MONTGOMERY COUNTY
PLANNING COMMISSION

July 16, 2025

Re: MCPC #25-0126-001
Plan Name: 1616 Whitehall Road Farm Improvement
(2 lots comprising 13.92 acres)
Situate: 1616 Whitehall Road/north of Windstorm Way
Worcester Township

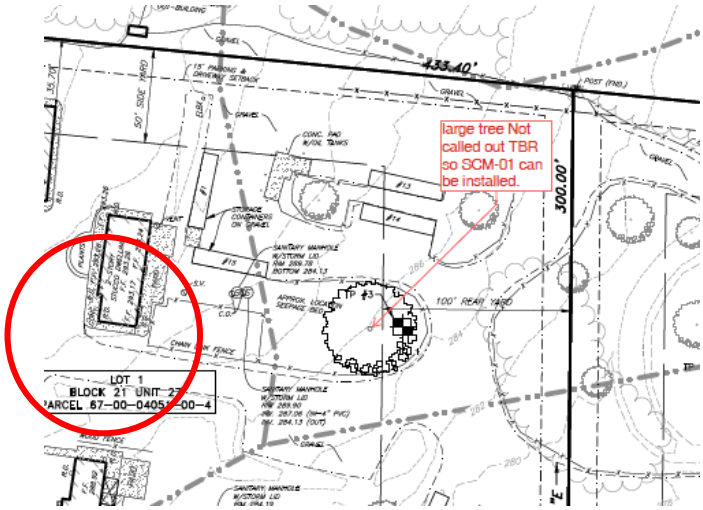
1) SCM-001 appears to conflict with the approximate location of an existing seepage bed. The township may wish to have the applicant locate the seepage bed to ensure proposed SCM-01 is not in conflict with the seepage bed.

2) A large mature shade tree is located on the site and existing conditions plan where SCM-01 is to be located. It is not marked for removal on the existing conditions plan however it is shown on the record plan as being removed. This tree would need to be removed to install SCM-01. The township should discuss with the applicant if there are alternate locations possible for the SCM-01 so the large mature tree could remain.

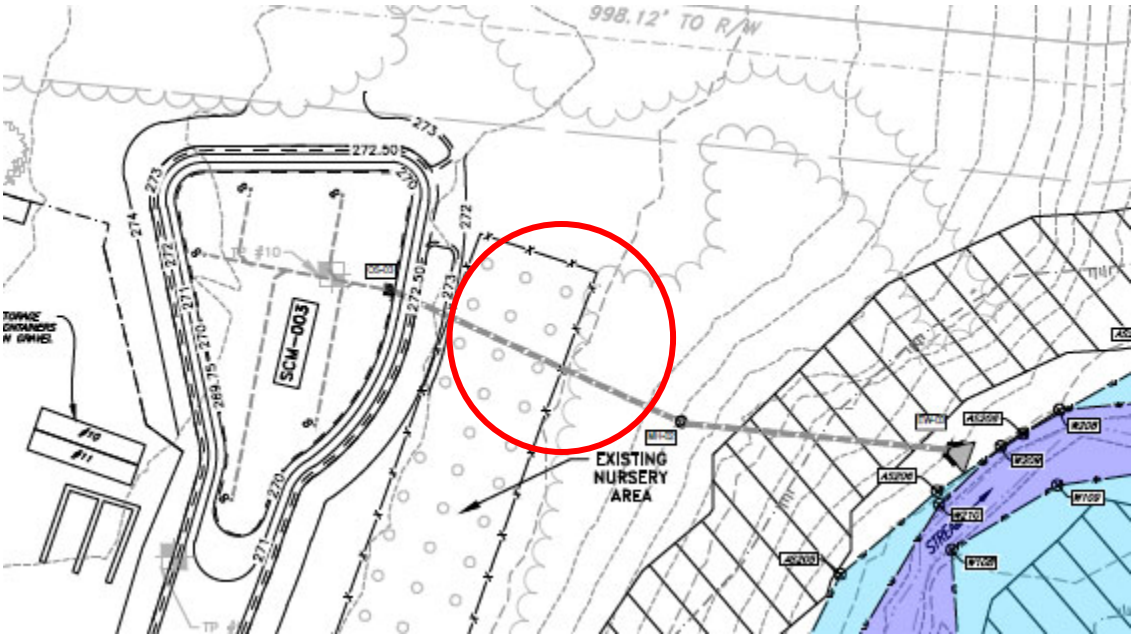
3) A stormwater inlet INL-03 is likely to be installed within the root zone of a tree to remain. Damage to the tree and critical root zone may occur during the construction of this inlet. The township may wish to discuss with applicant an alternative location for INL-03 outside the root zone of the tree. Alternatively, additional details/specifications could be added to protect the root zone of the tree in order to safely install the inlet and underground piping near the critical rootzone of the tree to remain.

4) Piping from SCM -003 to MH-02 appears to conflict with the existing nursery tree plantings. The township may wish to discuss with the applicant how the pipe will be installed without removing a portion of the fence and nursery trees.

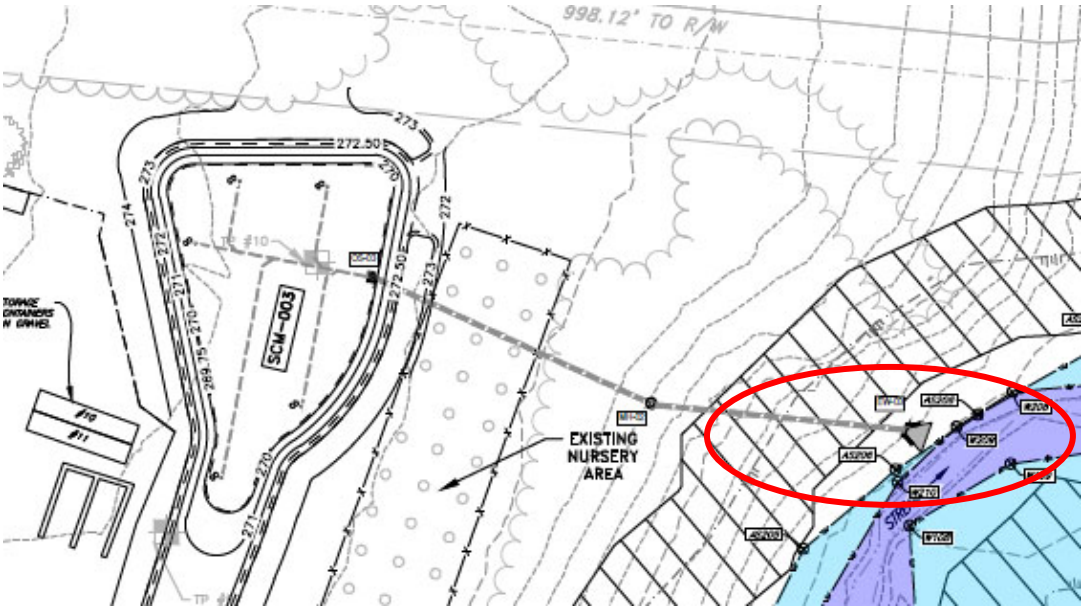
5) EW-02 outfall discharges onto the neighboring property and EW-03 outlet discharges into a wetland and stream at the rear of the property. Piping to EW03 is proposed through the riparian buffer. It is unclear how the pipe and outfall is to be constructed, and the riparian buffer protected or restored. According to Article XXB. Riparian Corridor Conservation District and § 150-146.12. Management of district, Item A states “Within any riparian corridor area, no construction, development, use, activity or encroachment shall be permitted unless a Corridor Management Plan is submitted and approved by the Township Board of Supervisors and the effects of such development are mitigated by the implementation of the Corridor Management Plan”. A corridor management plan does not appear to

have been submitted. The township may want to have the applicant submit a corridor management plan to restore the area impacted by the development.

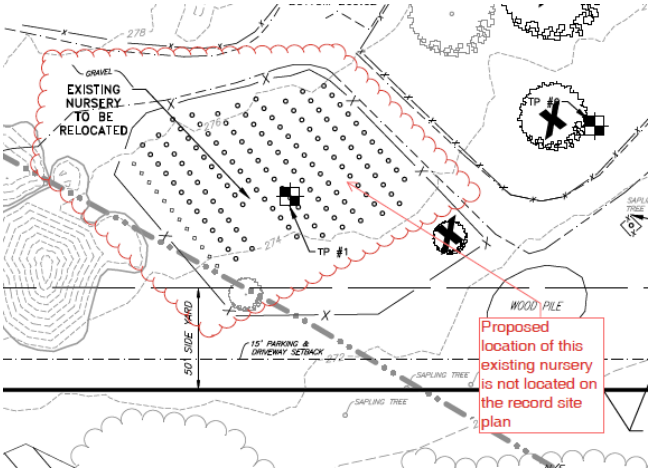
2. 11 trees to be removed as depicted on the Existing Facilities Plan. Replacement trees are not proposed. The township may wish to have the applicant discuss whether tree replacements are required or should not be required for this application.
